ND-2012-0053
September 28, 2012

Subject: **PSEG Early Site Permit Application**
Docket No. 52-043
Response to Request for Additional Information No. Env-04, ESP EIS
2.4.1 – Terrestrial and Wetland Ecology

RESPONSE to RAI No. Env-04

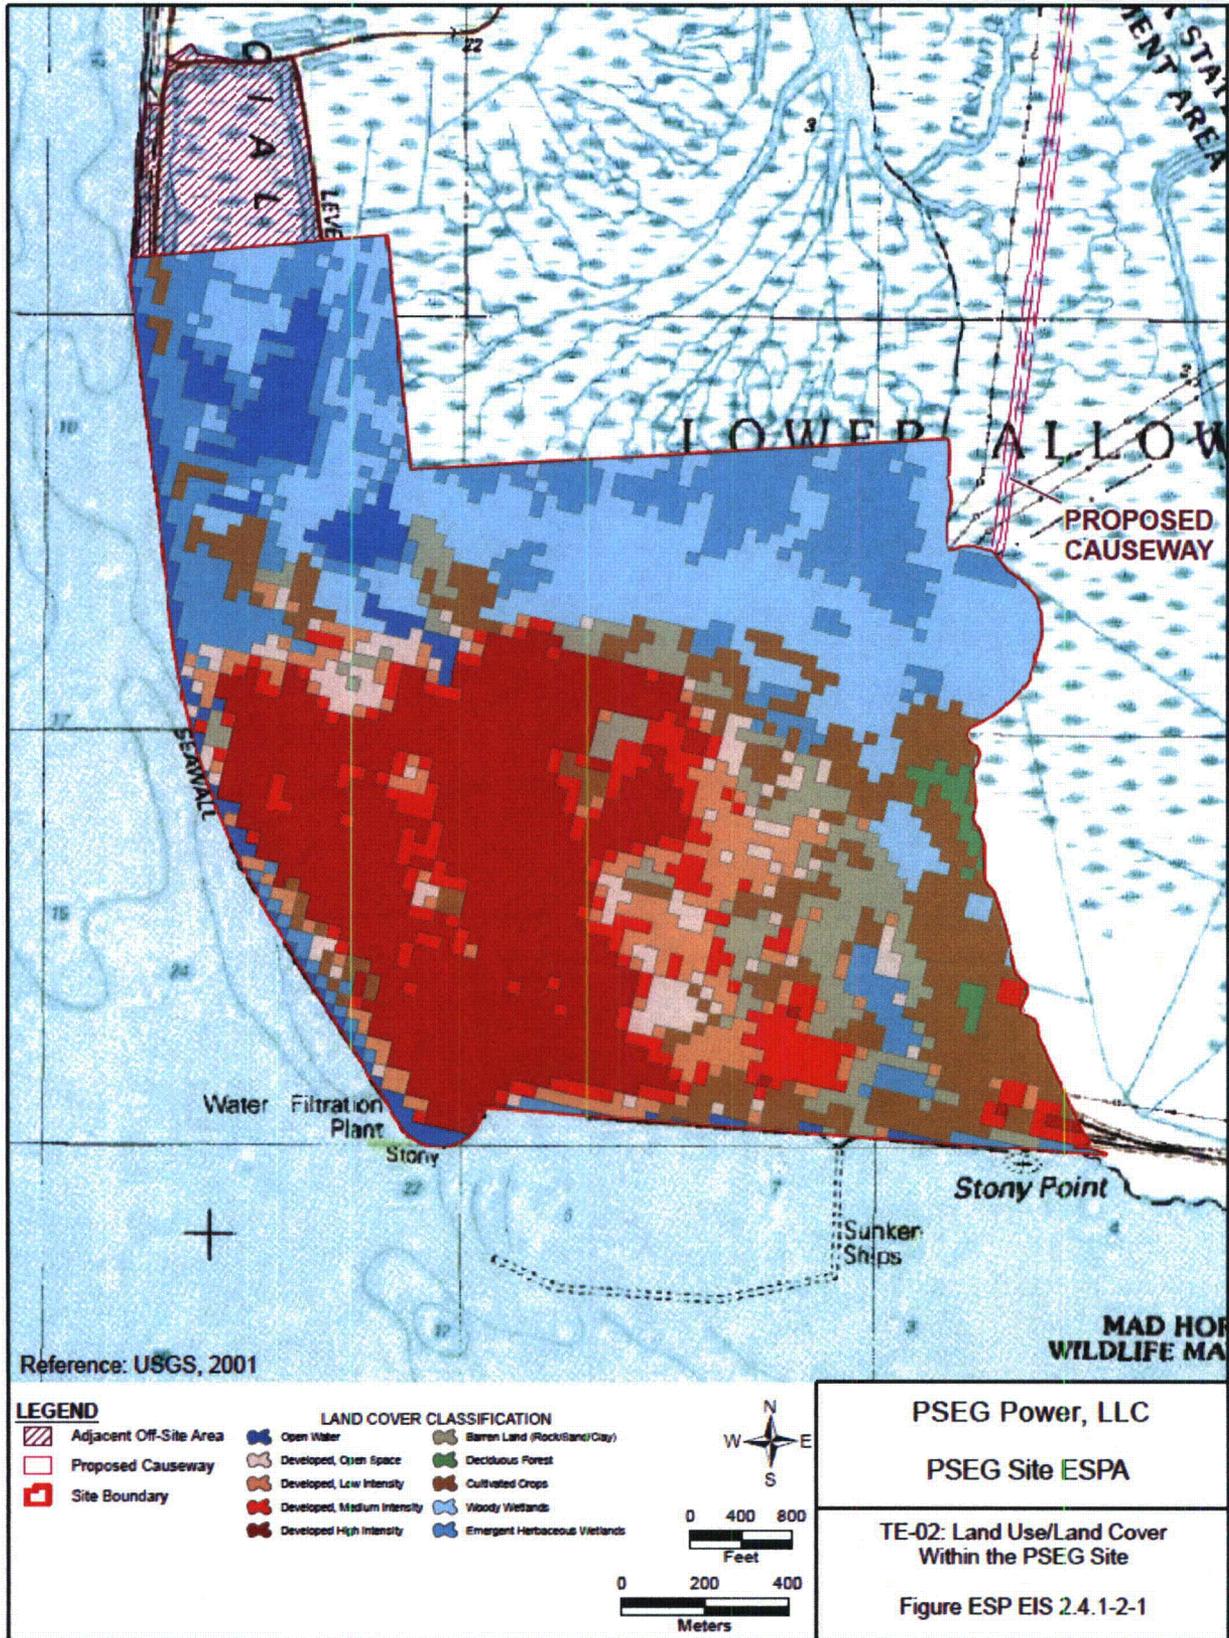
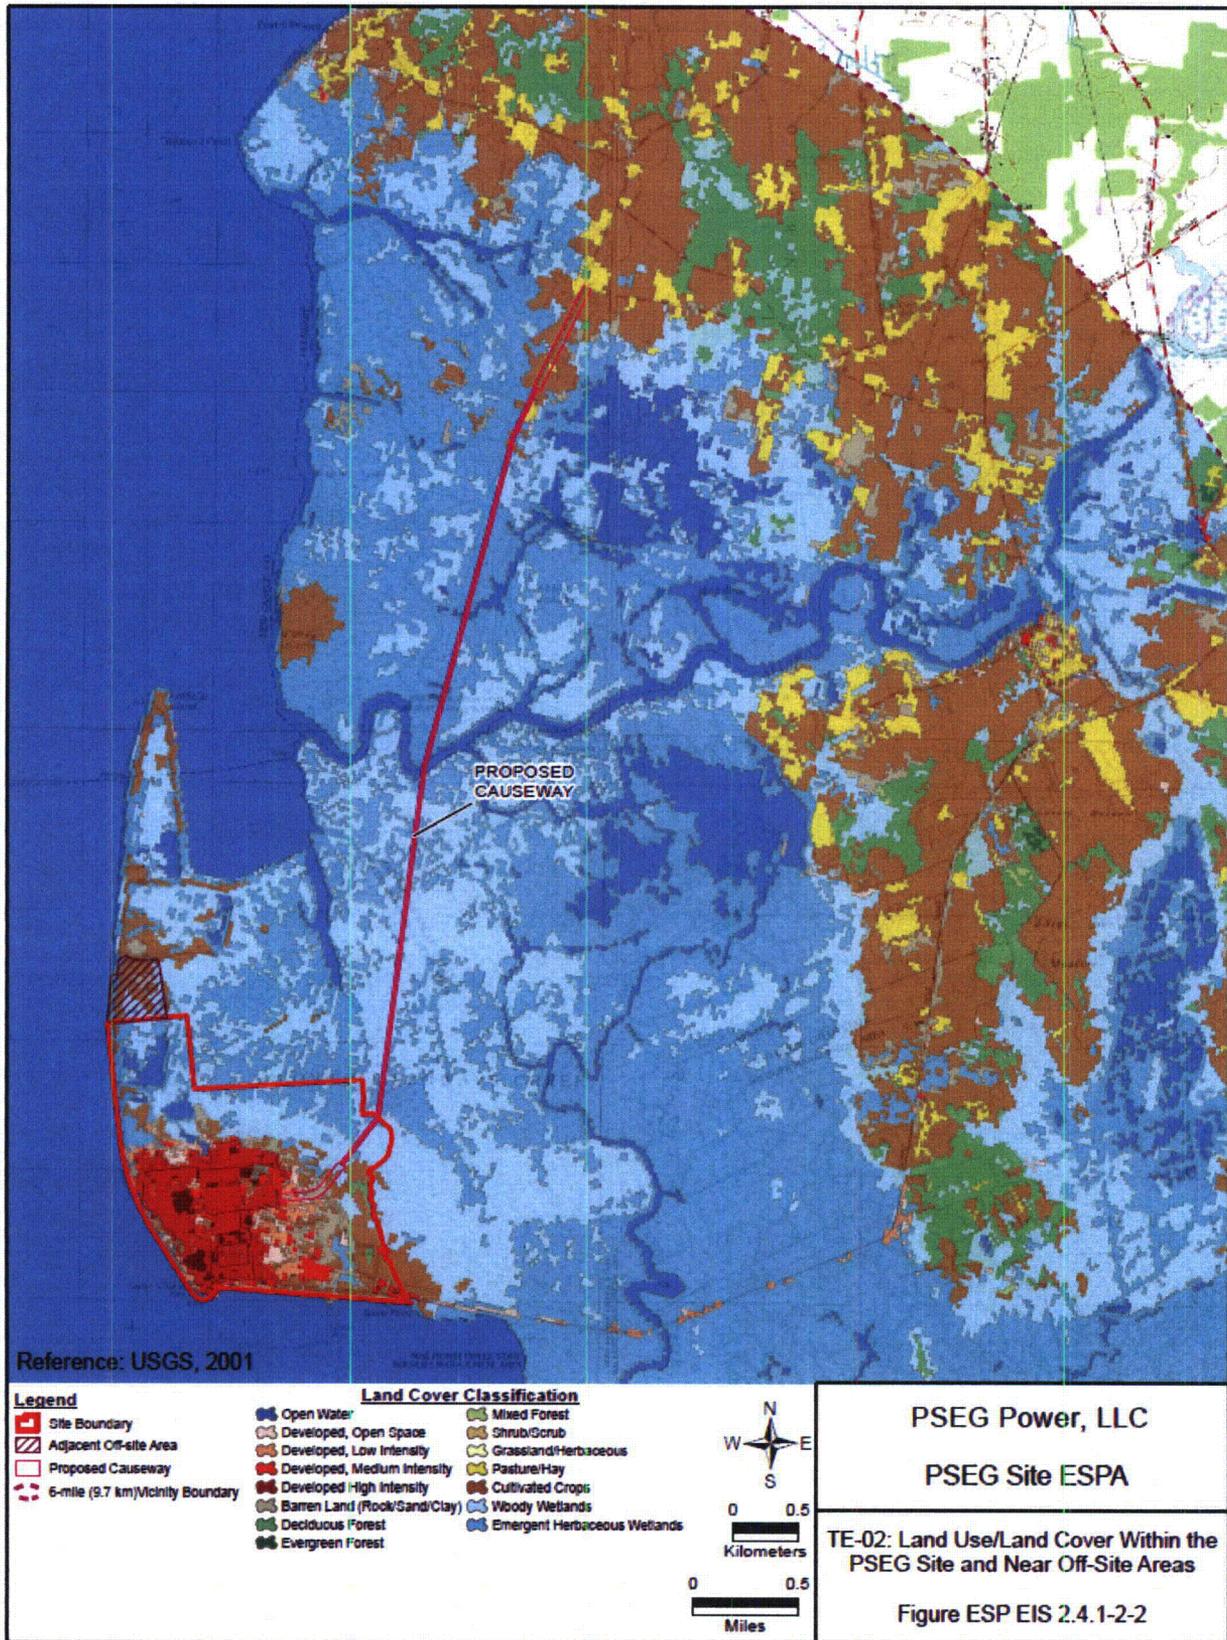
rTE-02: Provide a USGS Land Use/Land Cover-based cover type map for the proposed site.

Supporting Information: The color scheme used for the Land Use/Land Cover maps in ER Chapter 2 makes it difficult to distinguish different cover types. A more simplified version of these maps would help solve this problem.

The land use for the site and near off-site areas was previously analyzed using the New Jersey Land Use/Land Cover (LULC) database. In contrast, the U.S. Geological Survey (USGS) LULC database is used to analyze land use for the vicinity and region as this provides for a more unified database for the multiple jurisdictions within the larger region (DE, NJ, PA, and Maryland [MD]).

Because the New Jersey LULC data contains many more land use categories than the USGS data, it can make the colors difficult to discern. As requested, Figure ESP EIS 2.4.1-2-1 and Figure ESP EIS 2.4.1-2-2 depict the site and near off-site areas using USGS LULC data.

Figure ESP EIS 2.4.1-8-1
 Alternative Site 4-1 Open Space within 6-mile Radius

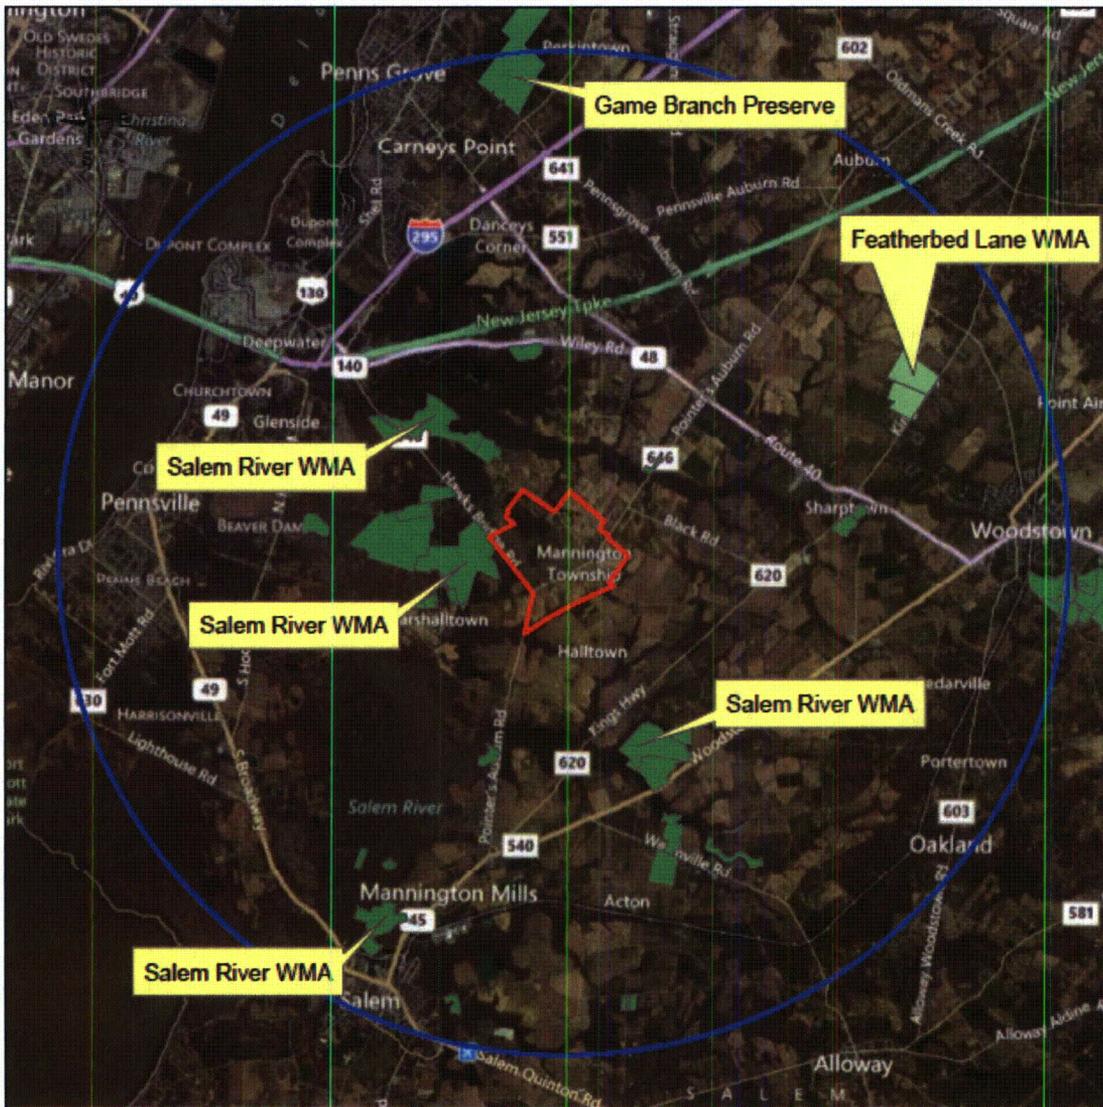
rTE-16: Provide additional information on the function of preserves and refuges in the vicinity of the alternative sites.

- Alternate Site 4-1 -- Figure ESP EIS 2.4.1-8-1
- Alternate Site 7-1 -- Figure ESP EIS 2.4.1-8-2
- Alternate Site 7-2 -- Figure ESP EIS 2.4.1-8-3
- Alternate Site 7-3 -- Figure ESP EIS 2.4.1-8-4

Delaware and Raritan (D&R) Canal State Park

The NJDEP's Division of Parks and Forestry, State Park Service, owns and manages the D&R Canal as a state park. The 70-mile Delaware and Raritan Canal State Park is one of central New Jersey's most popular recreational corridors for canoeing, jogging, hiking, bicycling, fishing, and horseback riding. The canal and the park are part of the National Recreation Trail System. This linear park is also a valuable wildlife corridor connecting fields and forests. A recent bird survey conducted in the park revealed 160 species of birds, almost 90 of which nested in the park. The D&R Canal Commission, legislated in 1974, assists with the development of the park and regulates land use in the park's 400-square-mile watershed. The New Jersey Water Supply Authority operates and maintains the water transmission complex of the canal as a water supply resource, pumping out about 75 million gallons of water a day (Reference ESP EIS 2.4.1-8-1).

Lockatong WMA

The Lockatong WMA is a 583-acre park along the Lockatong Creek in Franklin and Kingwood Townships (Reference ESP EIS 2.4.1-8-10). The site is comprised of mostly deciduous upland forest, deciduous wetland forest, and open field. Based on NJDEP Landscape Mapping v. 3.1, the site provides habitat for the State threatened American Kestrel (*Falco sparverius*), Savannah Sparrow (*Passerculus sandwichensis*), Grasshopper Sparrow (*Ammodramus savannarum*), and Bobolink (*Dolichonyx oryzivorus*).
